PALISADES NUCLEAR PLANT
EMERGENCY IMPLEMENTING PROCEDURE

TITLE: PROTECTIVE ACTION RECOMMENDATIONS FOR OFFSITE POPULATIONS

New Procedure/Revision Summary:

Revision 11

**PROTECTIVE ACTION RECOMMENDATIONS
 FOR OFFSITE POPULATION**

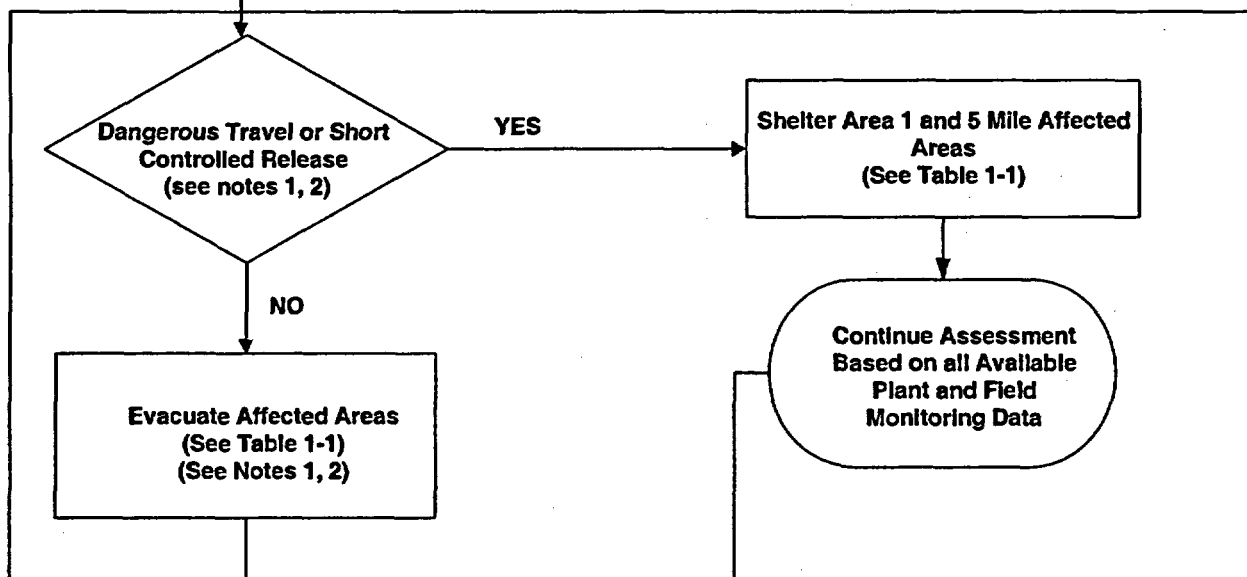
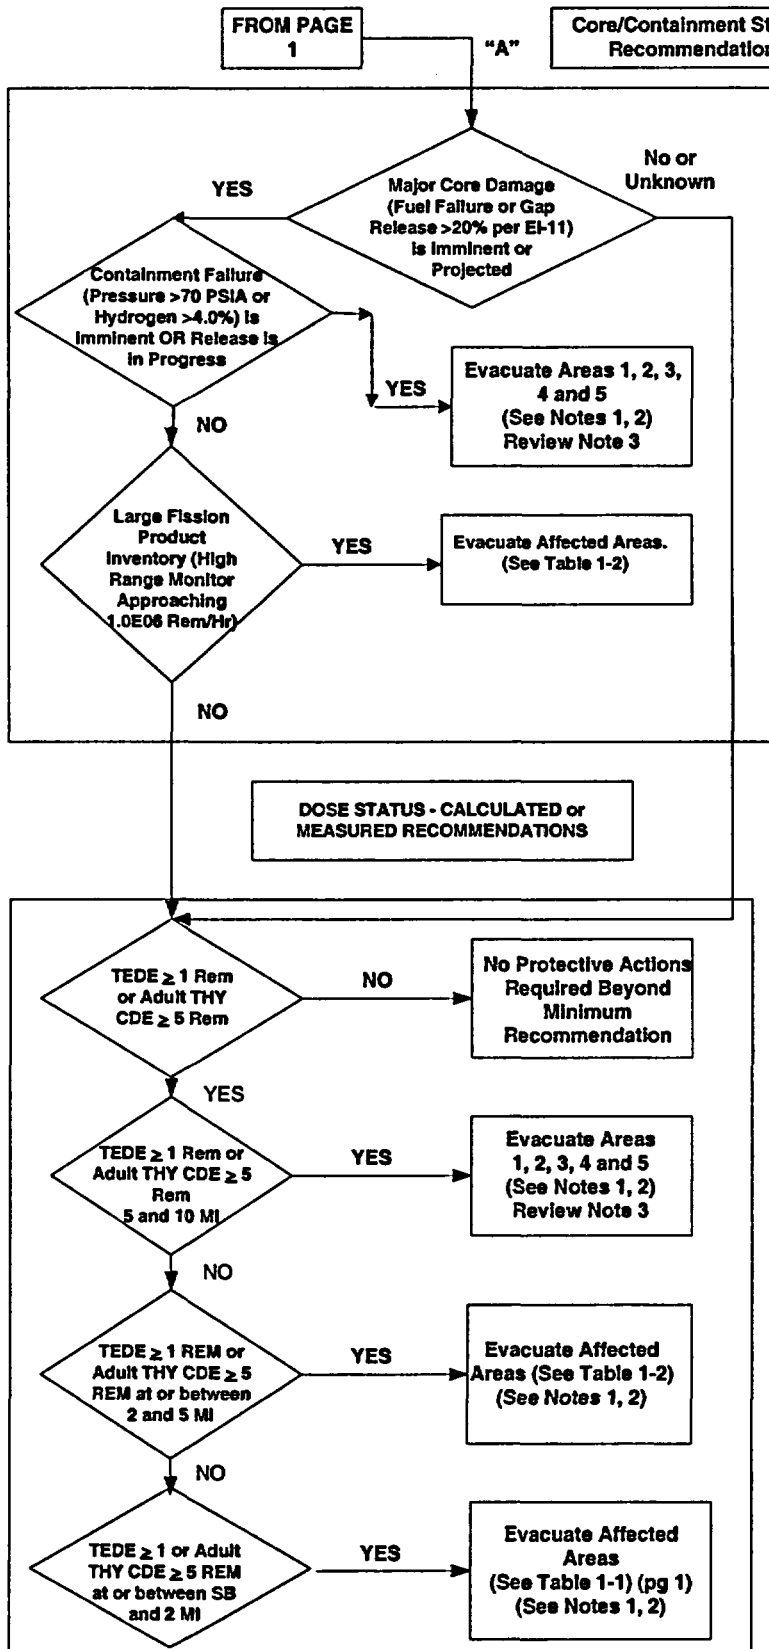
Attachment 1 was revised to make the flowchart clearer on the use of the minimum protective action box. The intent is to lead the user to consider all three protective action boxes for initial recommendations and not stop in the minimum box.

Additional changes to the wording in the protective action recommendations on the flowchart were made to include the use of the areas instead of only "radius". These changes were requested by the Operations Department as a result of procedure usage in license operator requalification training.
